**TOWN OF BAY HARBOR ISLANDS
MORRIS N. BROAD COMMUNITY CENTER
1175 95TH STREET
BAY HARBOR ISLANDS, FL 33154**

DEVELOPMENT & REVIEW COMMITTEE MEETING

Subject: Site Development Plan Application (2nd DRC Review)
1085 Townhouses – 6 DU Townhouse Complex
1085 94th Street
Bay Harbor Islands Acct. No. SPR24-000025
MMPA Account No. 01-0702-1197

MMPA recommends the Development Review Committee (DRC) **DEFER** action on the proposed Site Development Plan application at this time to allow the applicant's design team to address the listed comments. The submittal package has several design / Code violation issues, some of the plans are inadequate or missing and a few other items need to be corrected.

SITE PLAN,
SITE DATA &
LOCATION PLAN

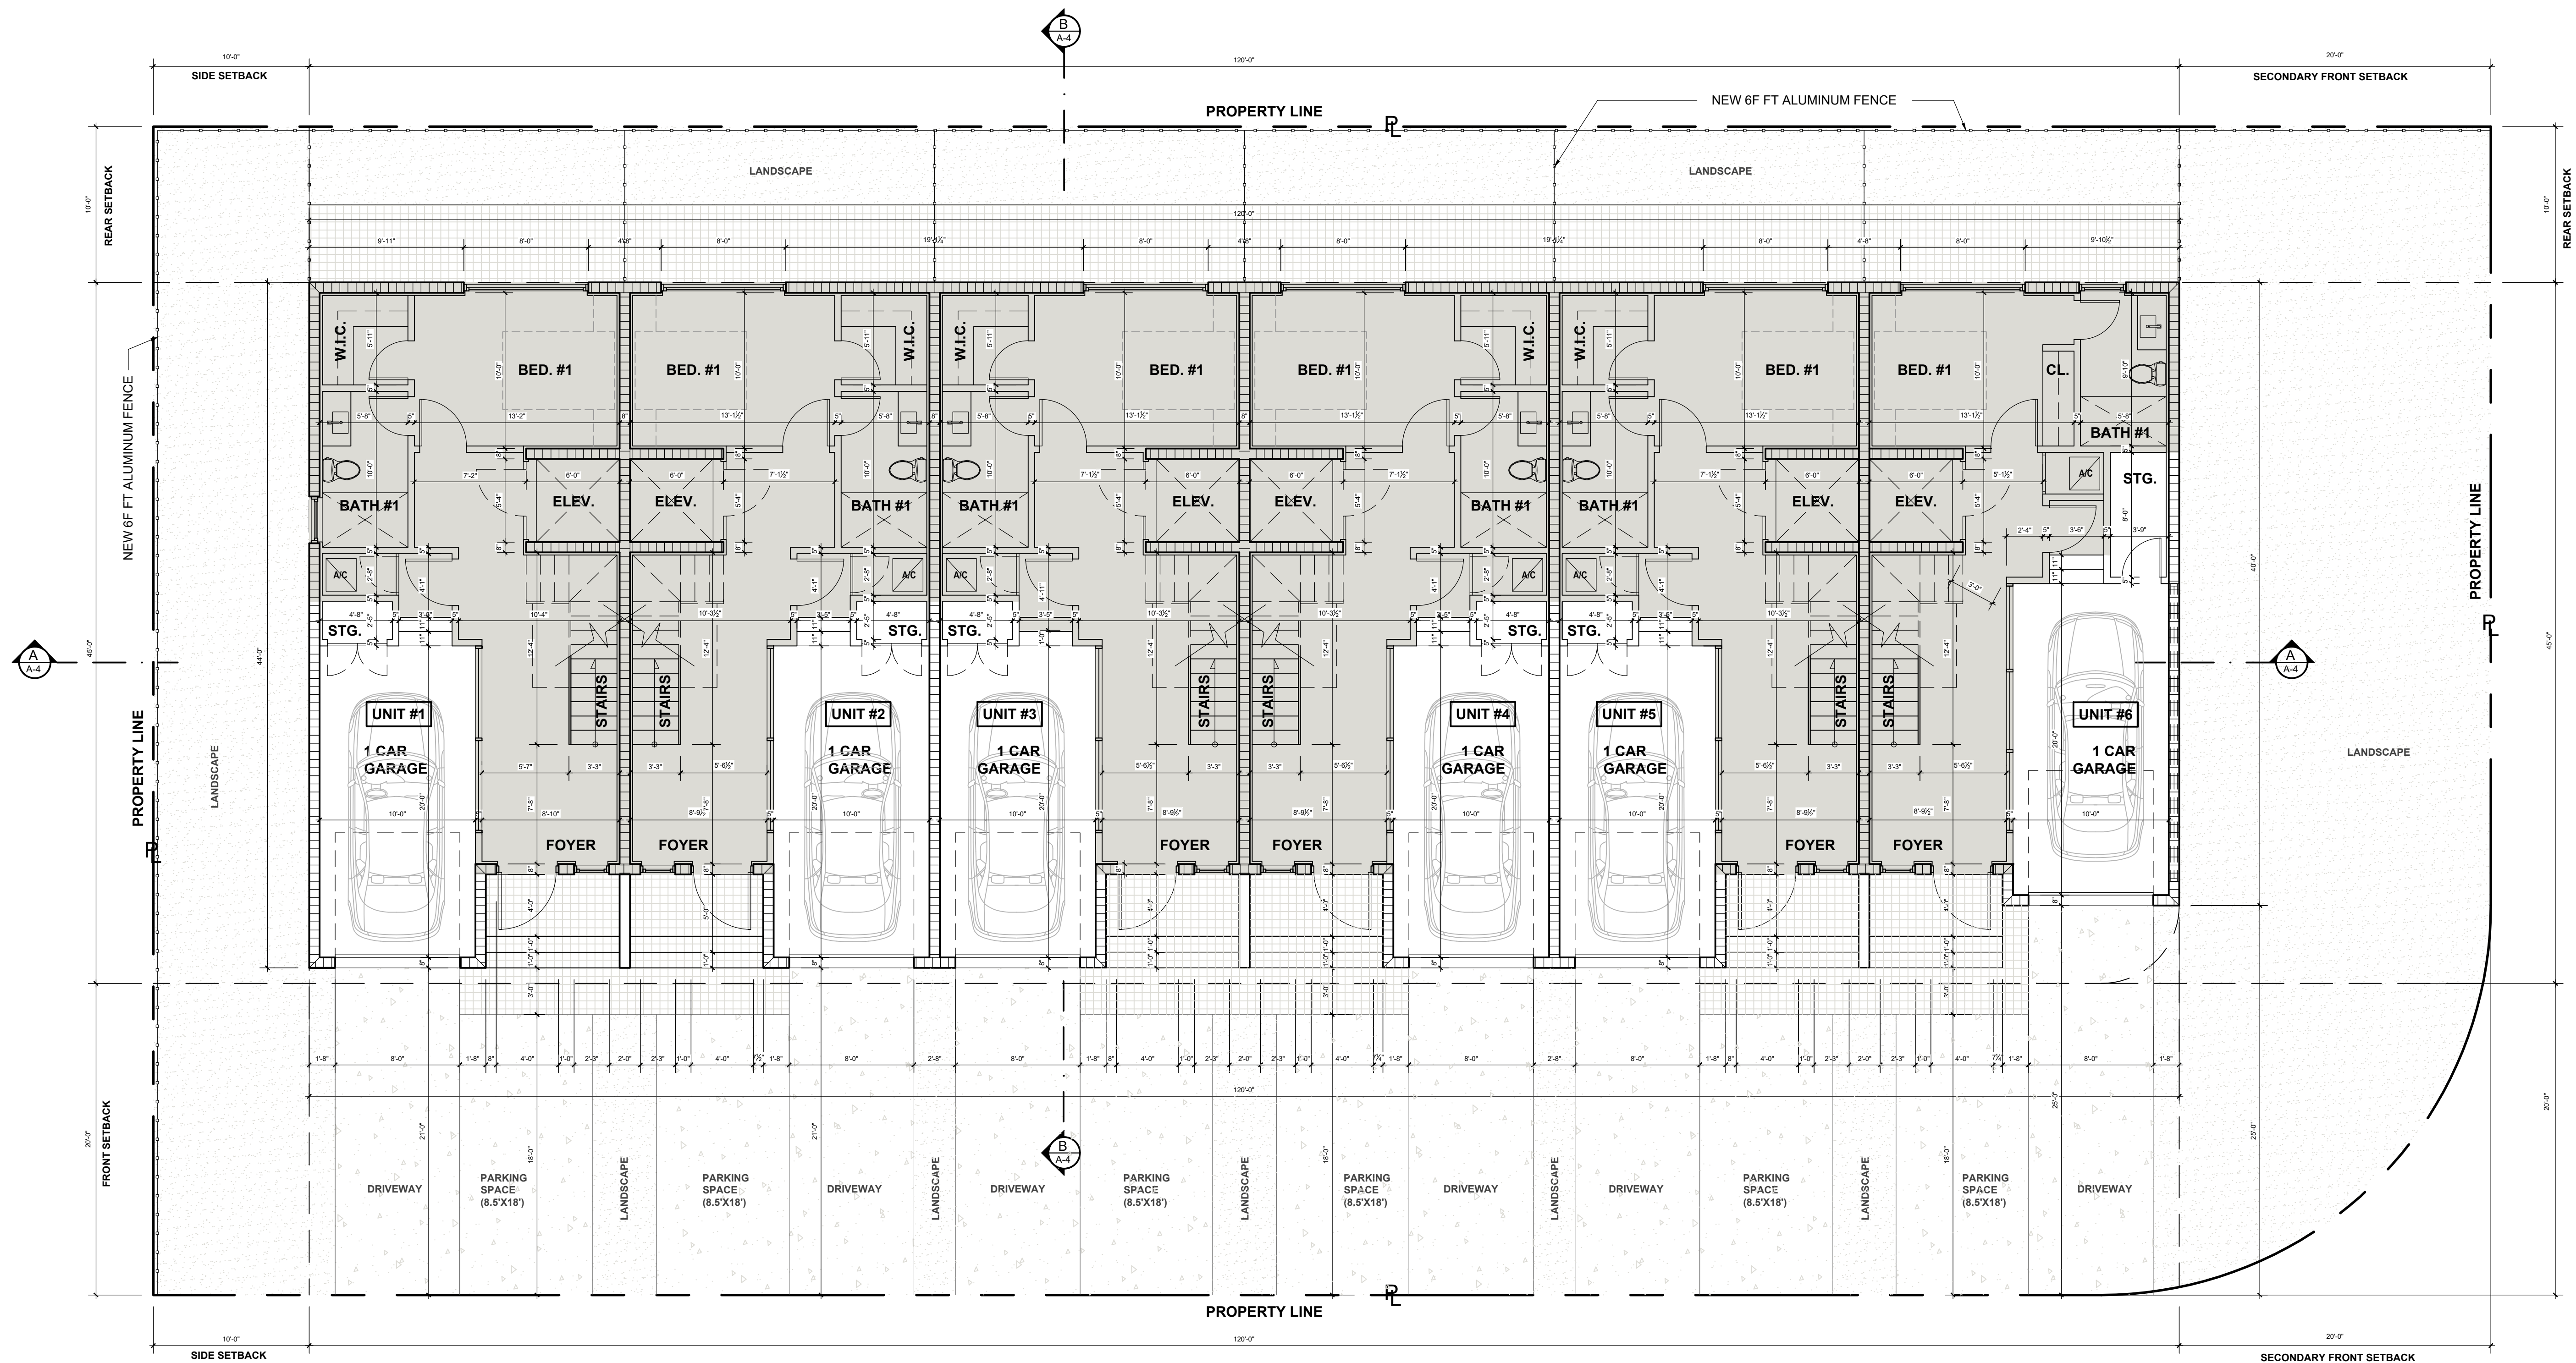
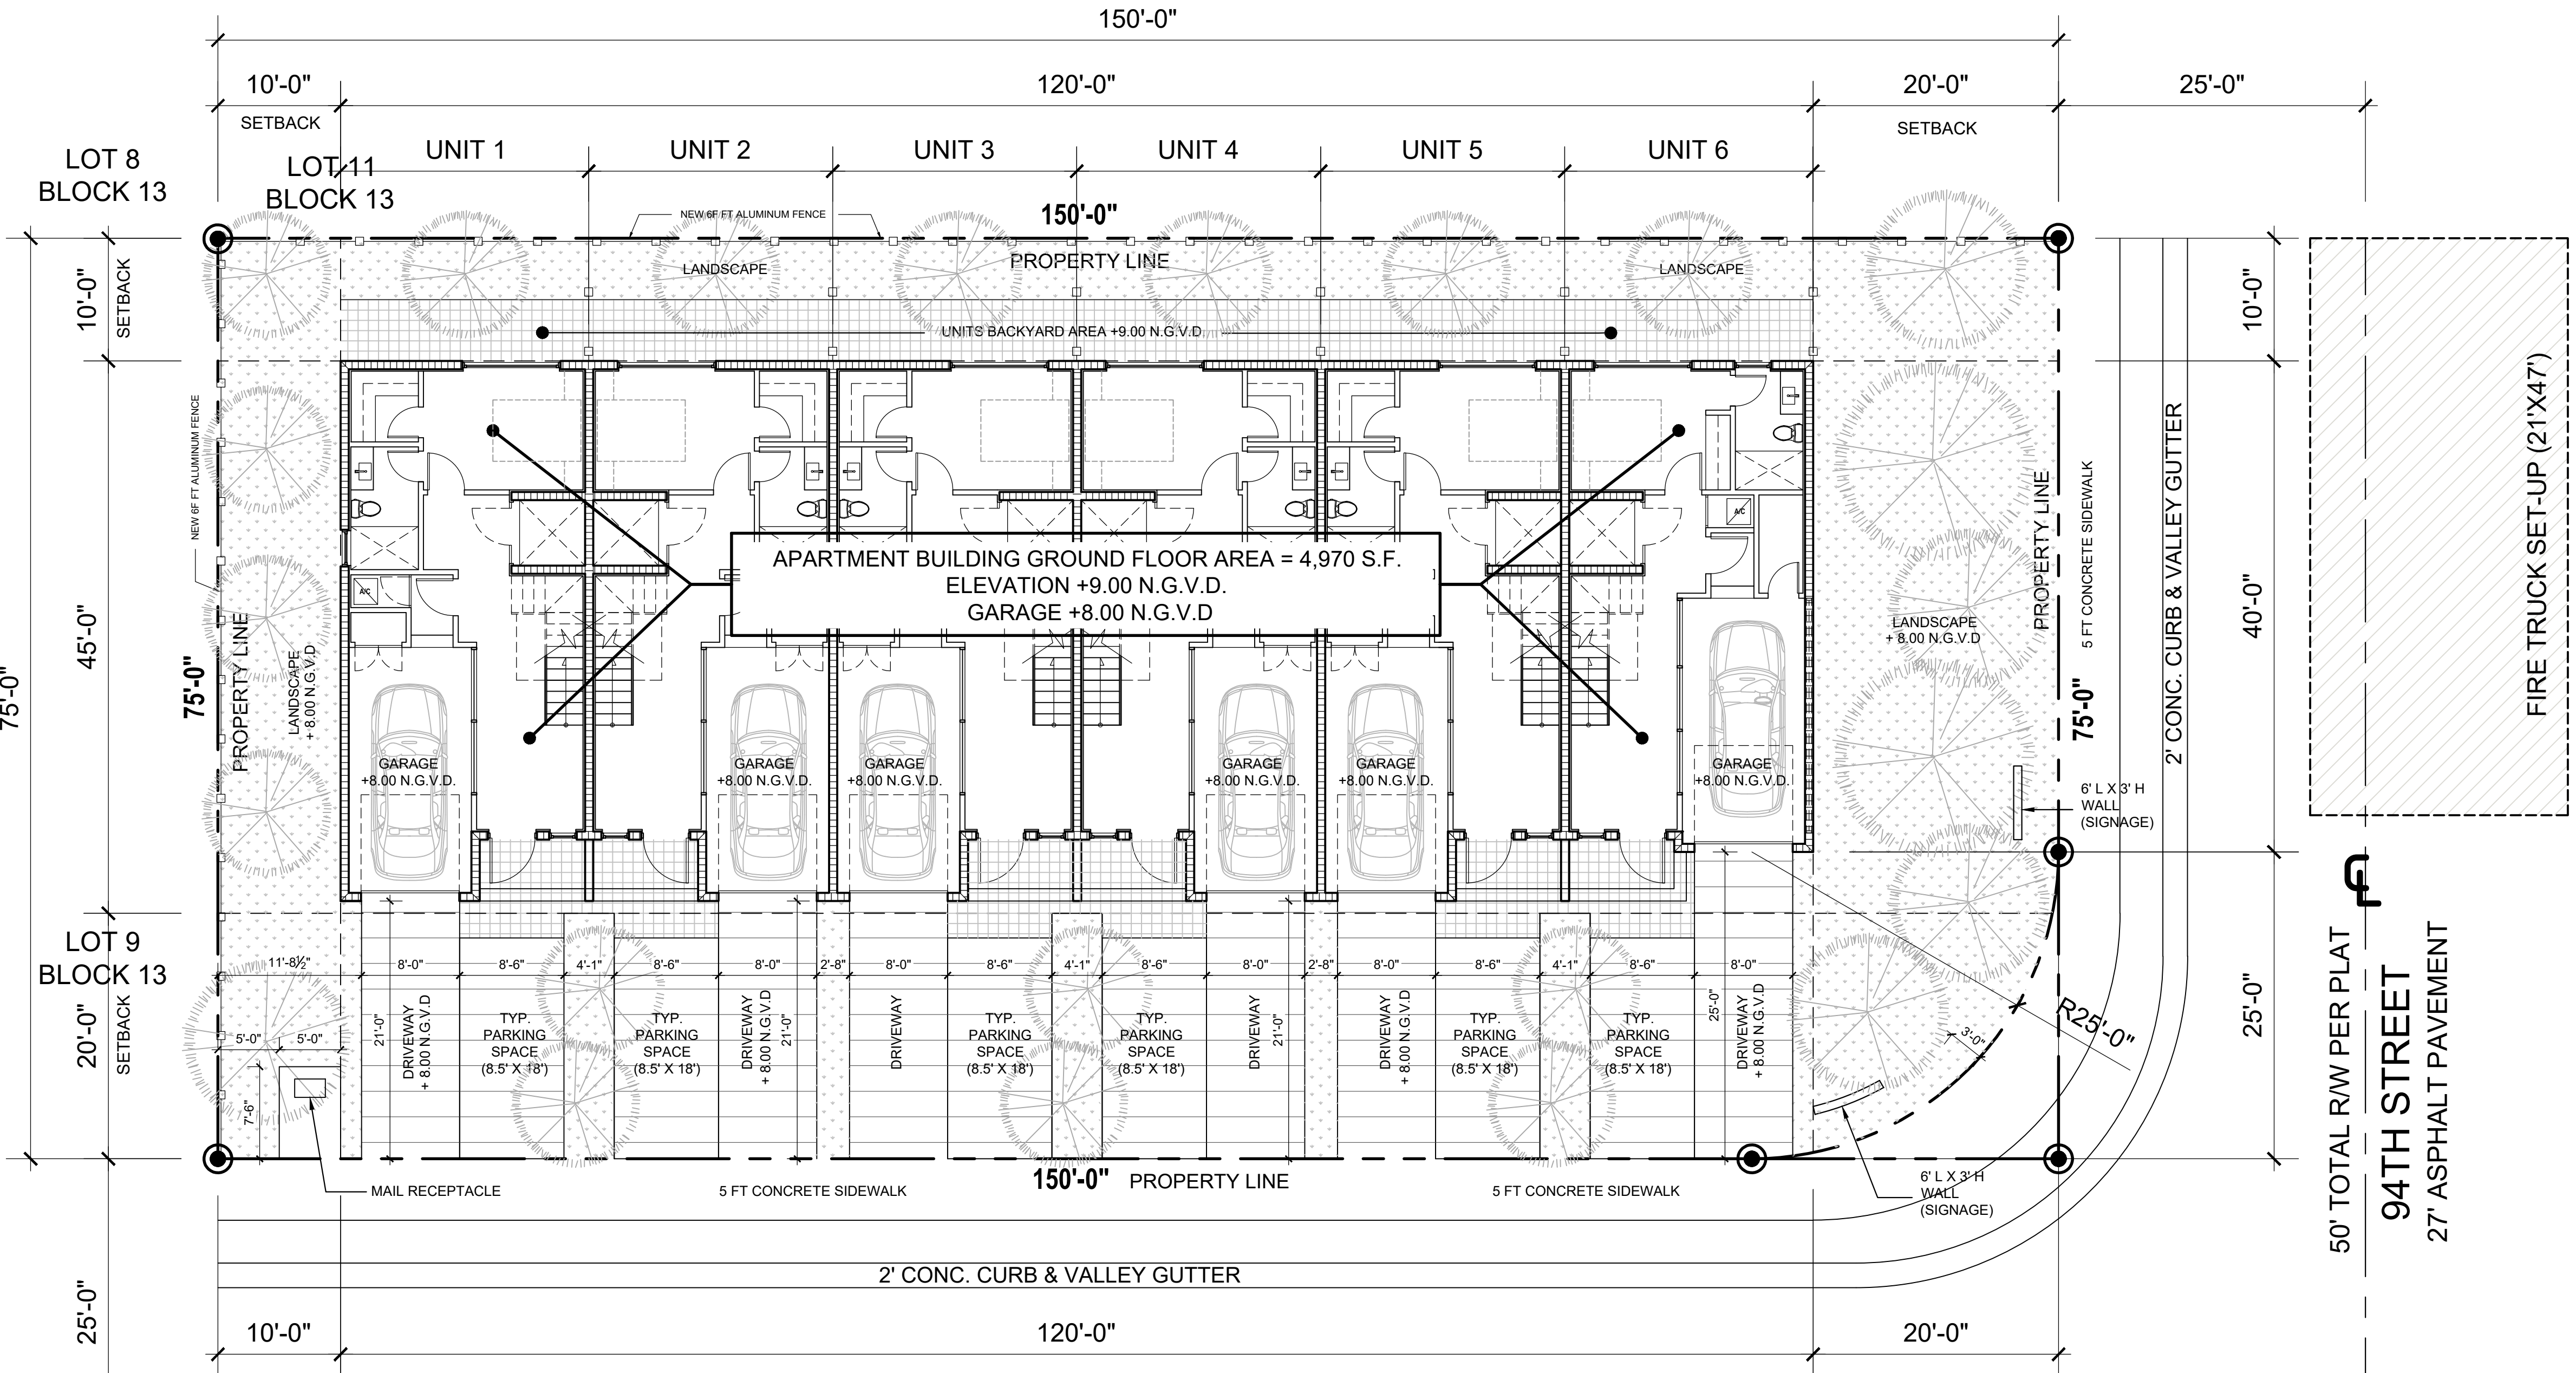
- 8) Site Plan A-1 has the following issues:
 - a. The proposed width of the individual driveways from the street to the garage doors at 8' appears too narrow. The minimum width of a parking space is 8'-6". MMPA suggests a 9' min. driveway width. Per Code Each driveway must be separated by a min. 2' landscape strip. All of the landscape strips exceed this – maybe reduce to adjust driveway widths.

- b. Per Sec. 23-24(d)(6)(b) no more than 50% of a property street frontage in a townhouse development may have hard driveway surfaces. This criterion does not appear to be met. Provide calculations demonstrating compliance.

- c. Dimension the width of the walkway at the rear of the building / add a setback dimension (3' min.).
 - d. Dimension the width of all front walkways. The maximum width is 5'.

- e. A drawing scale is provided – 1'-0" = 1/8". The drawing is not to scale.

- f. The elevation of the garages is now shown at 8.0' NGVD; however, on Sheet A-4 it is shown at 7.25' NGVD. Per Sec. 5-17 enclosed garages must be at least 18" above grade. Garage elevations must be at least 7'-2" +/- in elevation. Please revise.

- g. The original plans showed a fence / wall along the roadways – it appears to be deleted. However, the applicant's response letter states there will be short 2' wall setback 2' from the PL. We do not see this 2' wall on the revised plan set. Clarify.

- 11) Some features on the Site Plan (Sheet A-1) do not match other sheets (CE / Landscaping) like the curved wall at the corner. Please verify and make the plans internally consistent.

ROOF PLAN

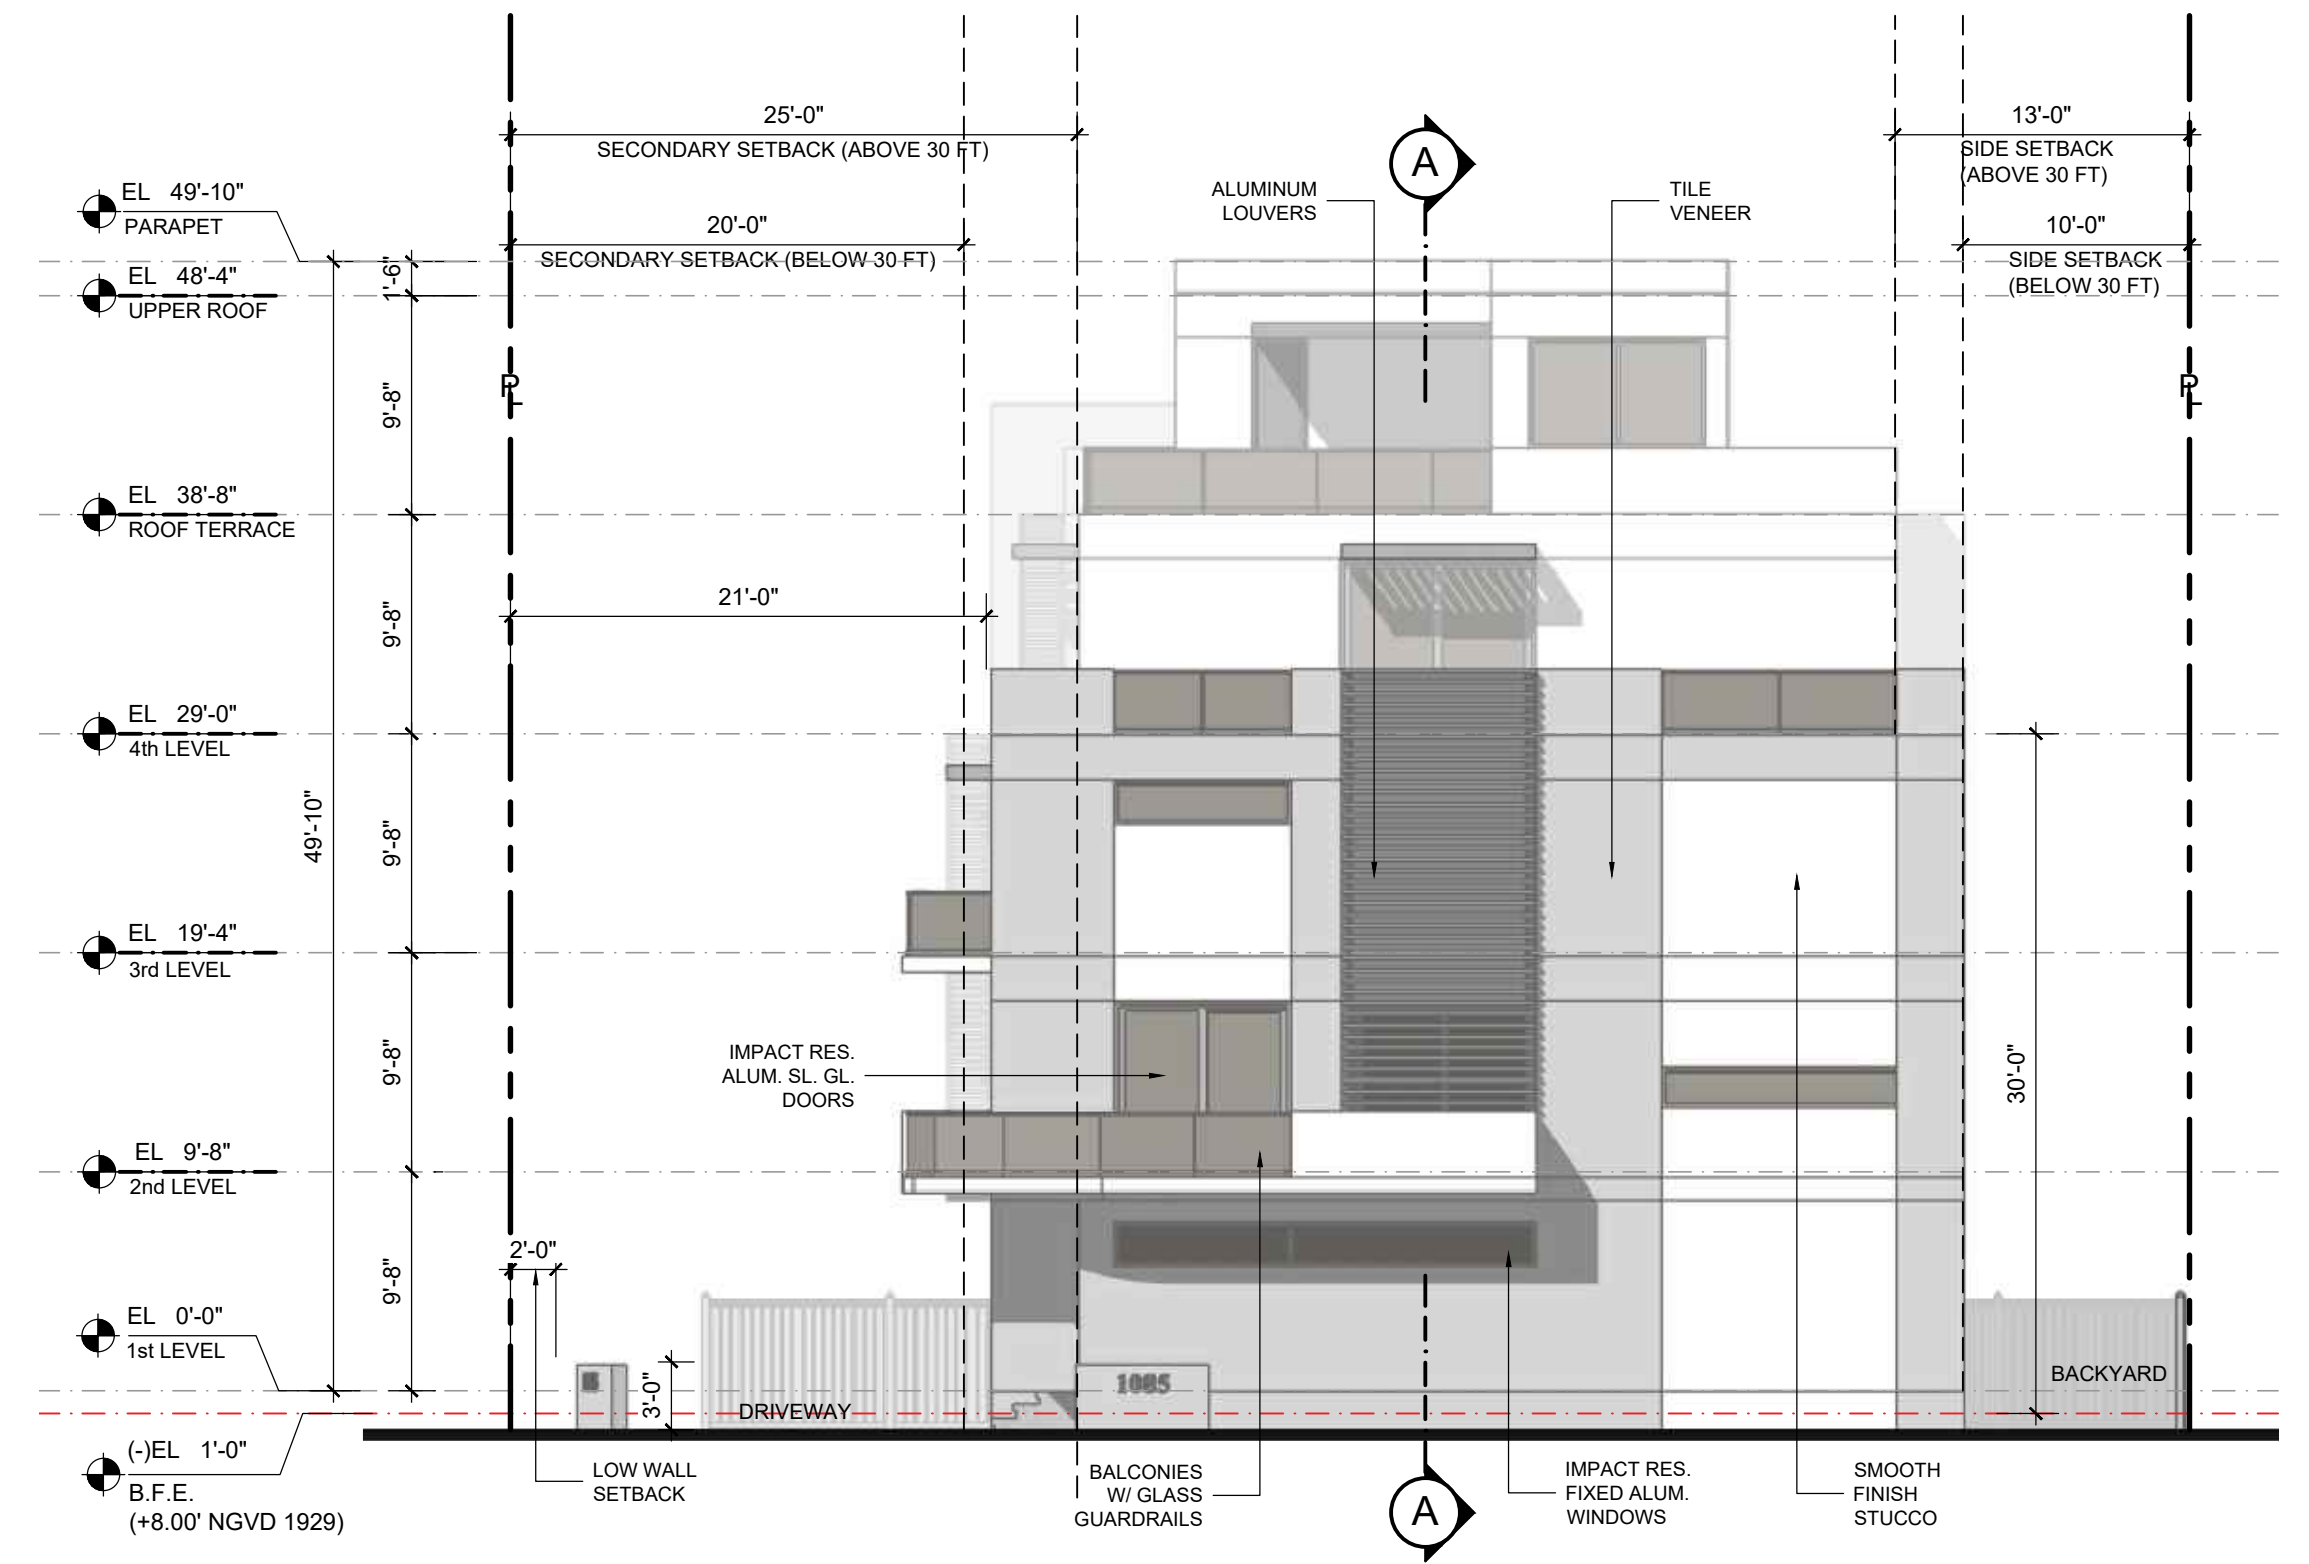
- As noted above the rooftop areas show undefined open roof areas. Rooftop recreation areas must have at least 15% of the areas used for recreation landscaped. Clarify the intended use of the rooftop areas. Revise the plans to add landscaping to the roof and add this calculation to the Landscape Requirements table as well as the roof plan.

Intended use for roof is for recreation. 15% of rooftop area is landscape (planters). Please refer to sheet A-2d / Roof top.
